Development Review Board Meeting Memorandum

Item No. 4
Topic: 49-DR-2022#2 (Mack Innovation Park Scottsdale – North Phase)
Action Requested: Review of applicant’s proposed revisions to project
Meeting Date: January 4, 2024
From: Meredith Tessier, Senior Planner
Through: Brad Carr, AICP, LEED-AP, Development Review Board Liaison

MACK INNOVATION PARK

SEC of Loop 101 and Pima Road
Development Review Application
Application 49-DR-2022#2

L.01 / 03

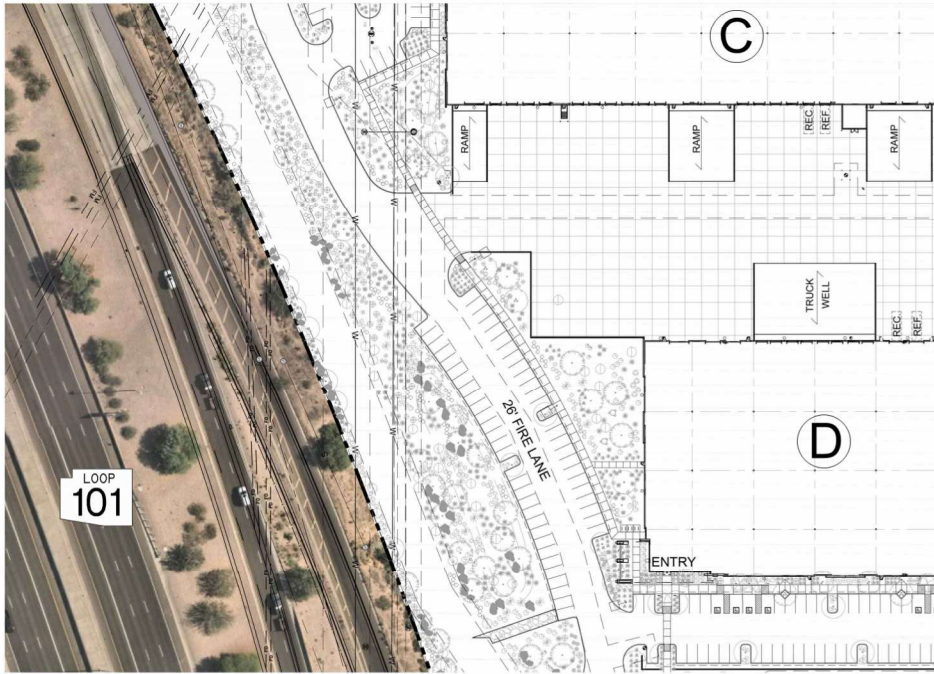
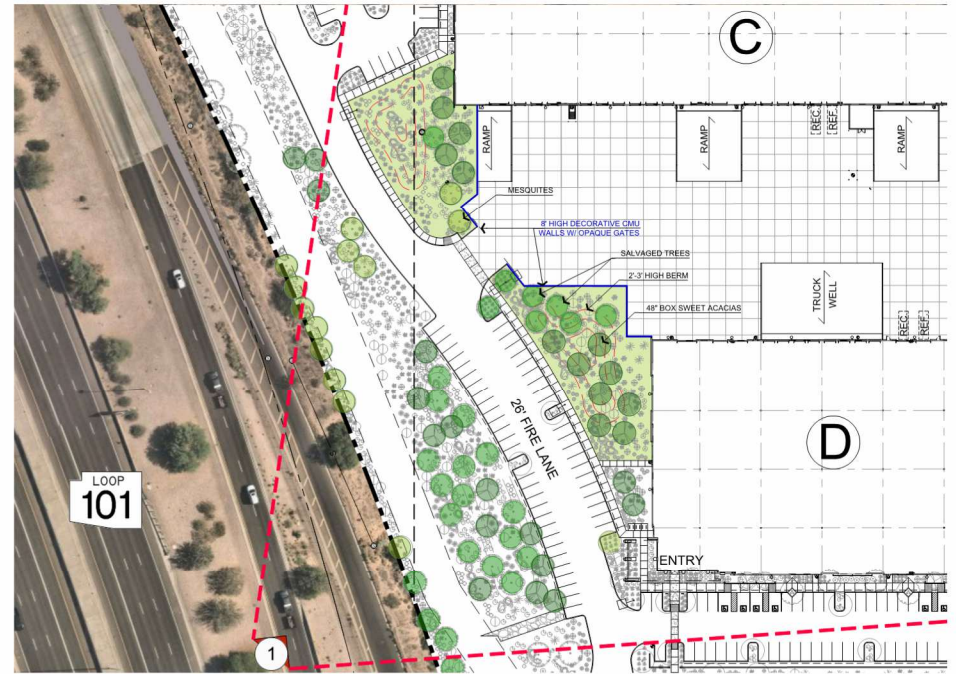
Updated Pima Rd landscaping

- The mixed-use trail along N. Pima Road has been shifted further into the site (away from N. Pima Rd) to allow more space for trees along N. Pima Rd.
- New trees are added on the Pima side of the mixed-use trail to provide better shading on both sides of the sidewalk.
- Site plan and landscape plan updated to depict both existing and proposed City of Scottsdale utilities and Arizona Department of Transportation (ADOT) right-of-way

CURRENTLY PROPOSED
SCALE: 1"=50'

PROPOSED REVISIONS
SCALE: 1"=50'

3' PARKING SCREEN WALL
LANDSCAPE EXHIBIT

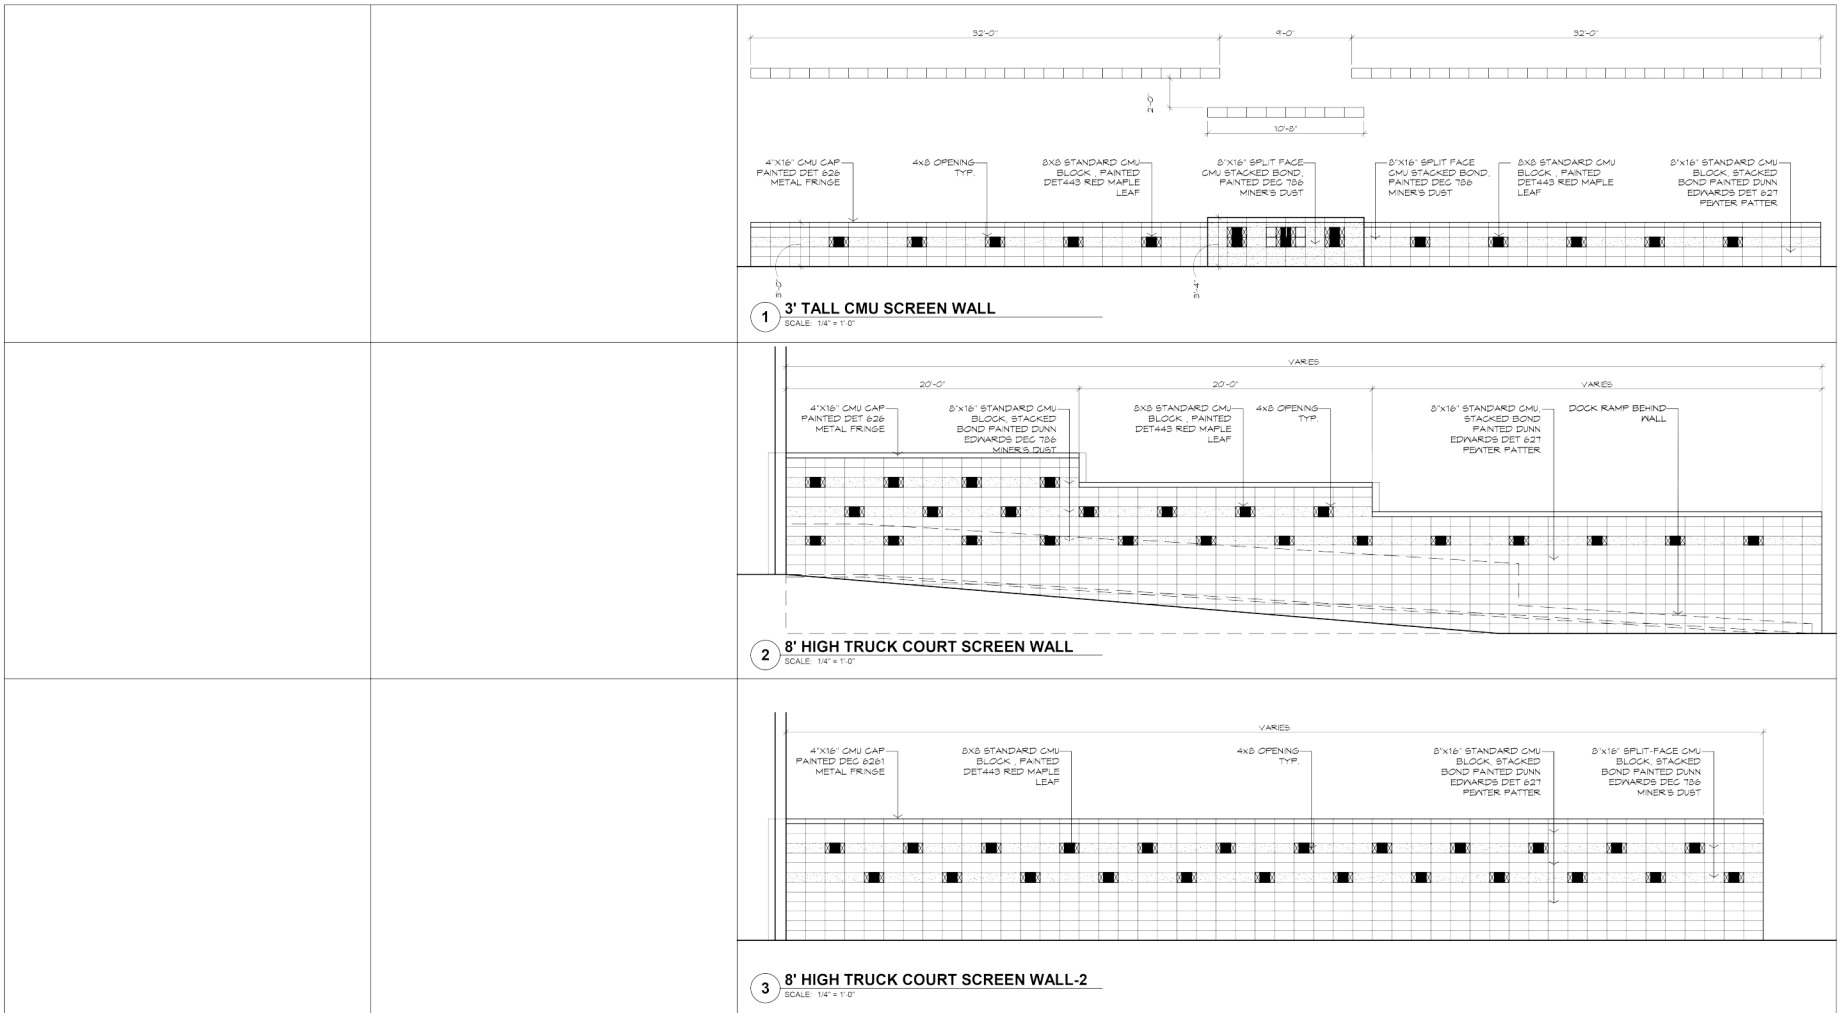
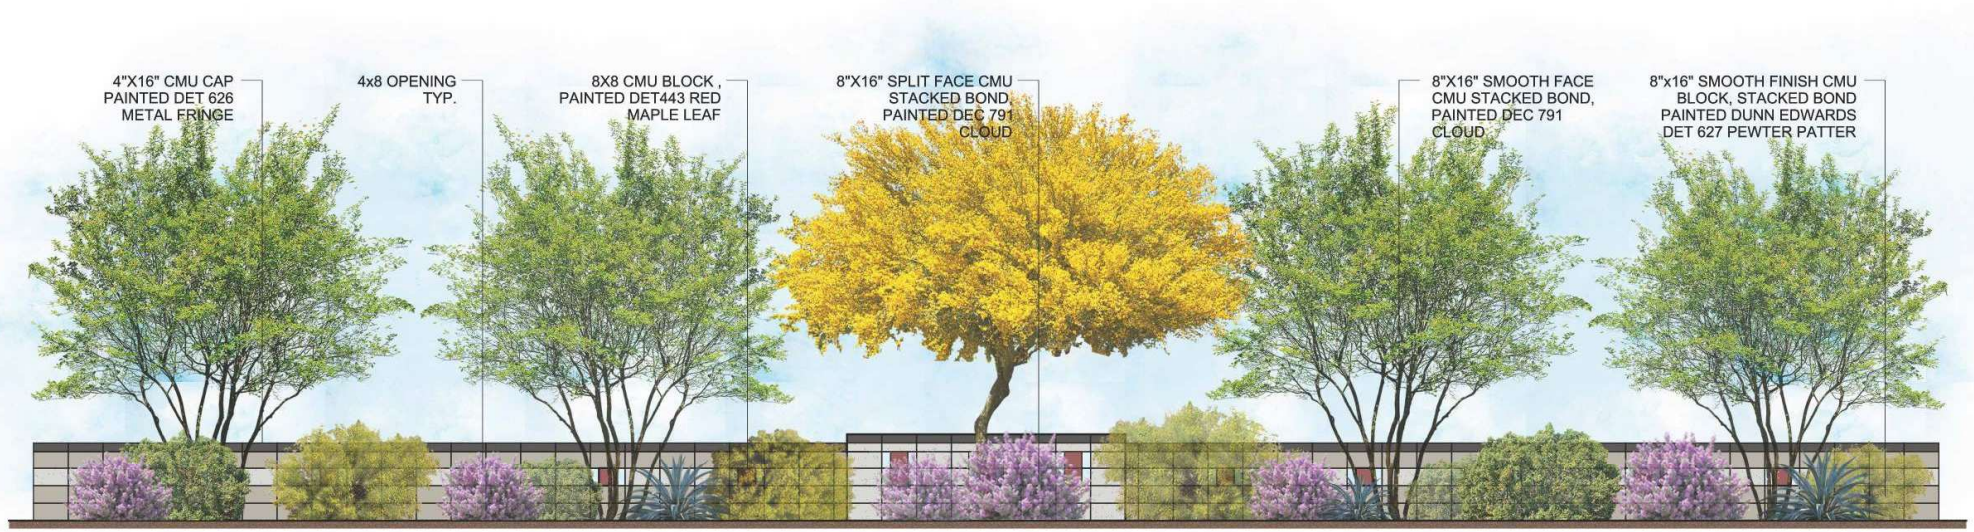
Screen walls

- Expanded the screen walls at the ends of the shared truck courts to block the view to the interiors from the surrounding public road.
- Reconfigured and expanded the landscape areas adjacent to Buildings C & D to accommodate more and larger trees so that the shared truck court is better screened from the 101 Freeway and Frontage Road.

2A BLDG B* - ENLARGED MIDDLE ENTRANCE
 SCALE: 1/8" = 1'-0"
 * SIMILAR FOR BUILDINGS C & D

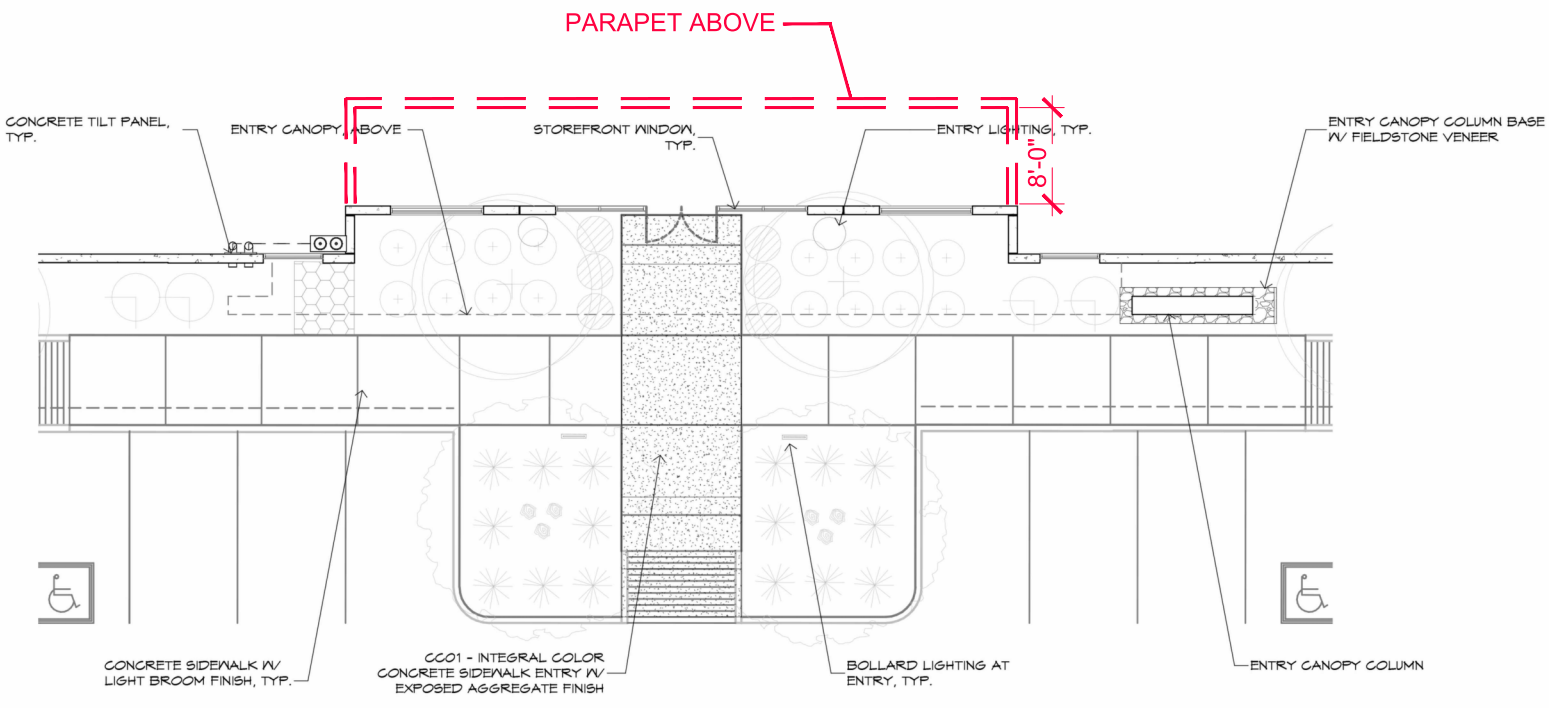
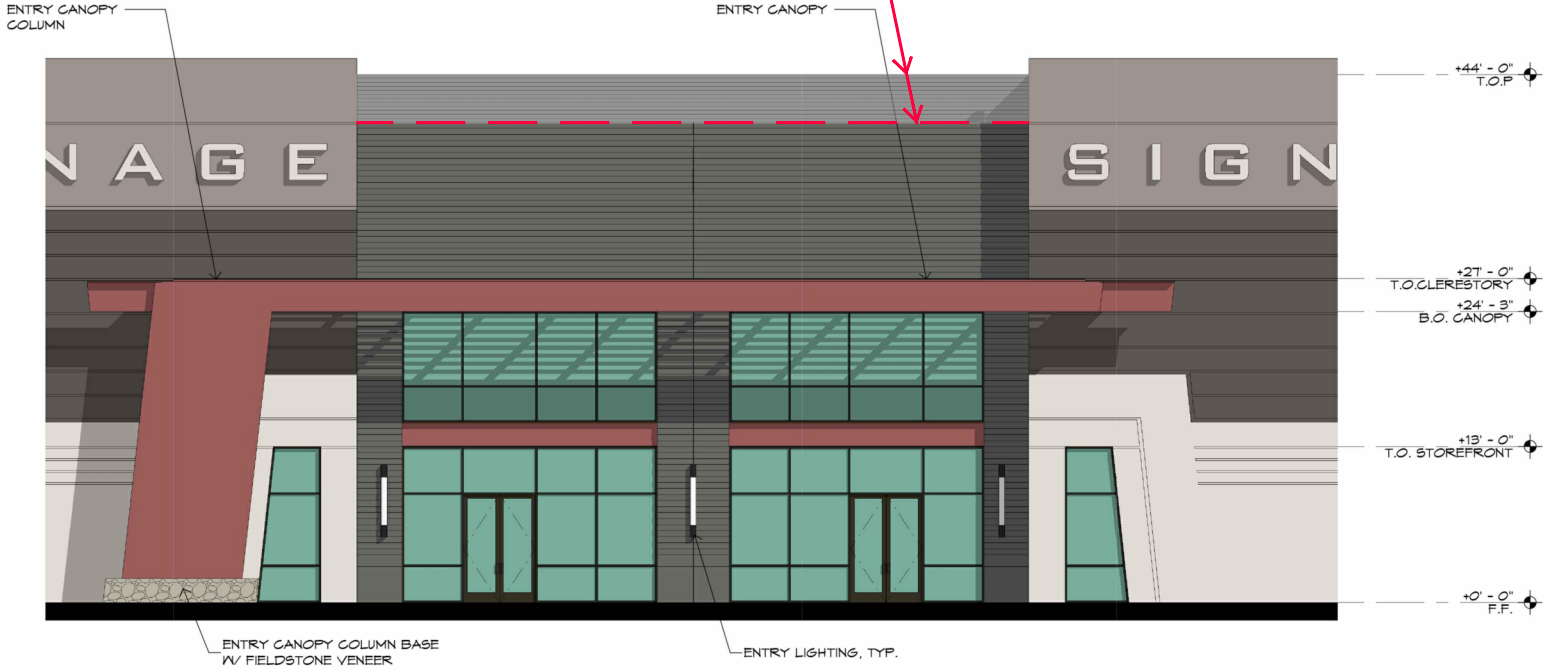
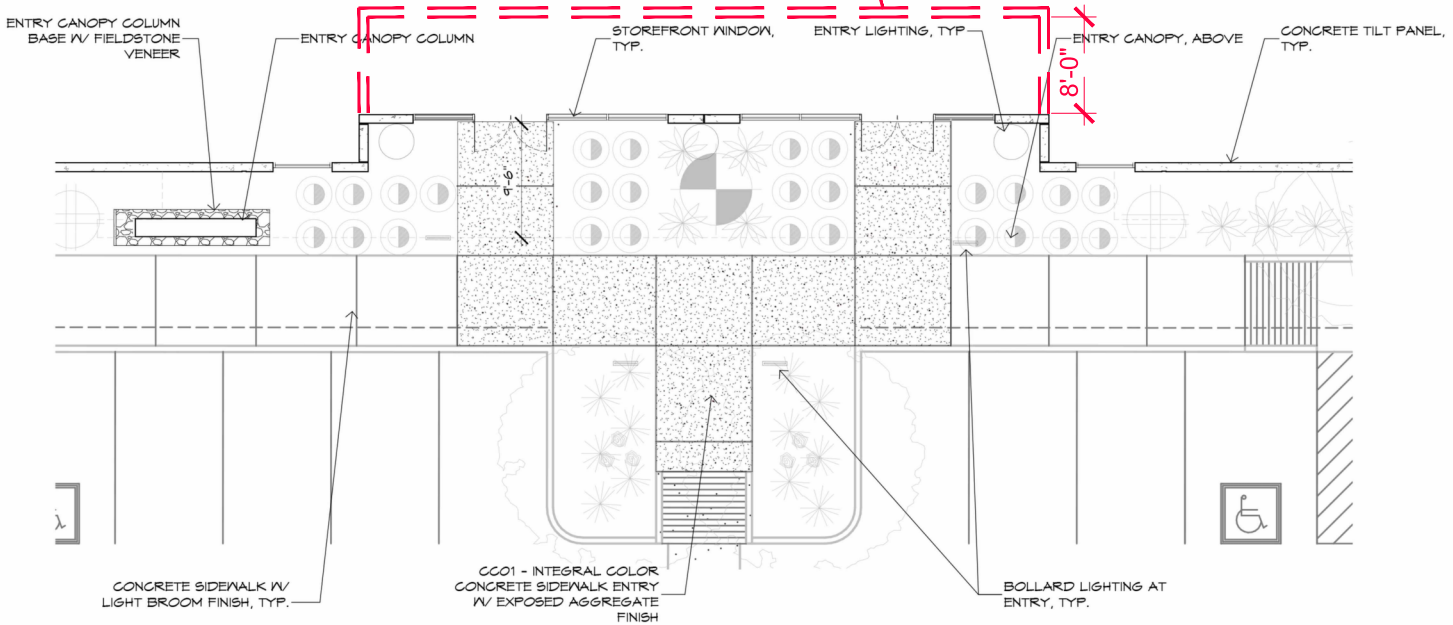
Updated Building Elevations

- Modified sections of the building parapet walls to increase and decrease height as well as provide setbacks in certain areas. The overall effect will break up the monotony to the building facades, which effectively will make the buildings appear broken up and/or smaller.
- Updated building elevations to show all 4-sides of the North Phase buildings.

I serve as DC Ranch's Director of Public Affairs, representing the 7000+ Scottsdale residents who live in DC Ranch. After reviewing Mack's new exhibits, it is very disappointing that less than 10% of each building front received the addition of recessed walls (building step) as requested by DRB to reduce the mass of the buildings. NO recess was added to the back of these 750+ foot warehouses. There is more than adequate space above the garage doors to safely allow for recessed areas. DC Ranch is requesting that DRB require Mack to:

PARAPET LOWERED AND A SECONDARY PARAPET HAS BEEN ADDED 8' BEHIND PRIMARY PANEL
